U.S. NUCLEAR REGULATORY COMMISSION
AUDIT SUMMARY FOR THE REGULATORY AUDIT
OF NUSCALE POWER, LLC DESIGN CERTIFICATION APPLICATION CHAPTER 4,
“REACTOR”; CHAPTER 5, “REACTOR COOLANT AND CONNECTING SYSTEMS”; AND
CHAPTER 9, “AUXILIARY SYSTEMS”

Figure 2. SIMULATE5 Radial Reflector Region Diagram

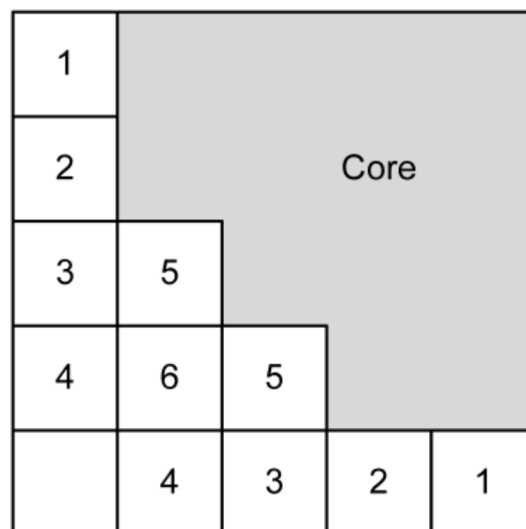
The NRC staff requested the NuScale clarify the neutronic modeling of the radial reflector region. NuScale provided the following explanation:

- The modeling of the radial reflector in the NuScale RXC is split into multiple segments matching the square array and pitch of the fuel assemblies. The radial reflector segments are identified according to their position around the core and the relative material composition of the segment, as shown in Figure 3-5 of the TR-0616-48793, “Nuclear Analysis Codes and Methods Qualification Topical Report,” (provided below as Figure 2 for completeness). [
